# UNITED STATES PATENT AND TRADEMARK OFFICE

APPLICATION NO.	FILING DATE	FIRST NAMED INVENTOR	ATTORNEY DOCKET NO.	CONFIRMATION NO.
10/620,940	07/11/2003	Ronald Ray Catt		8881

**Office Action Summary**

## **DETAILED ACTION**

FIG. 1

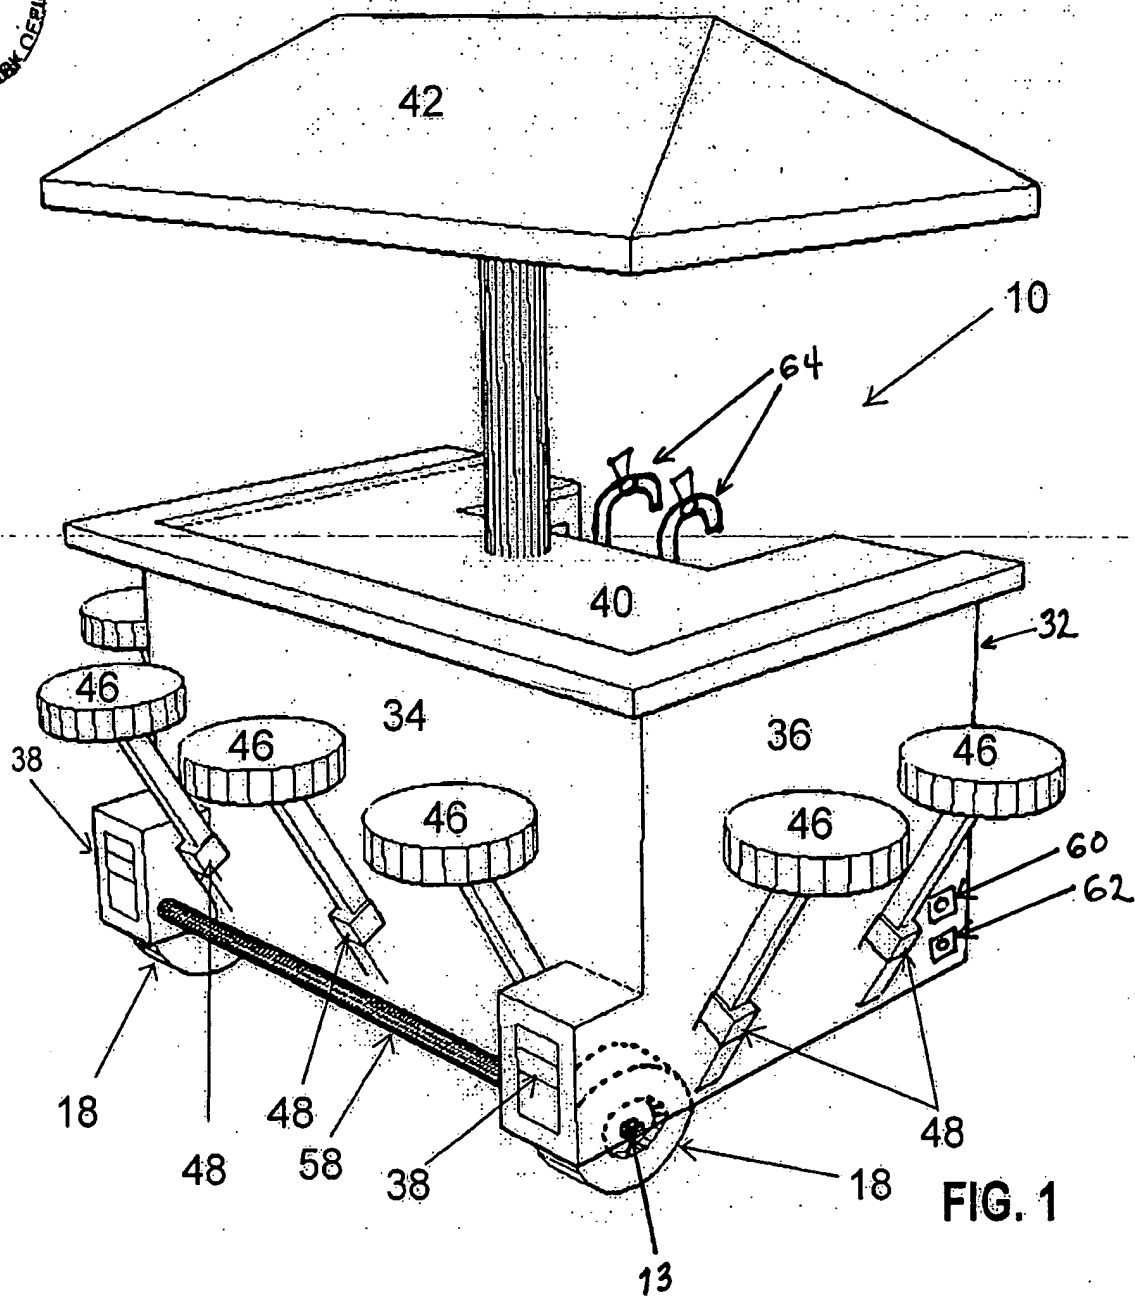
Figure 1, filed 7/21/2005 is approved.

approved  
8/2/05
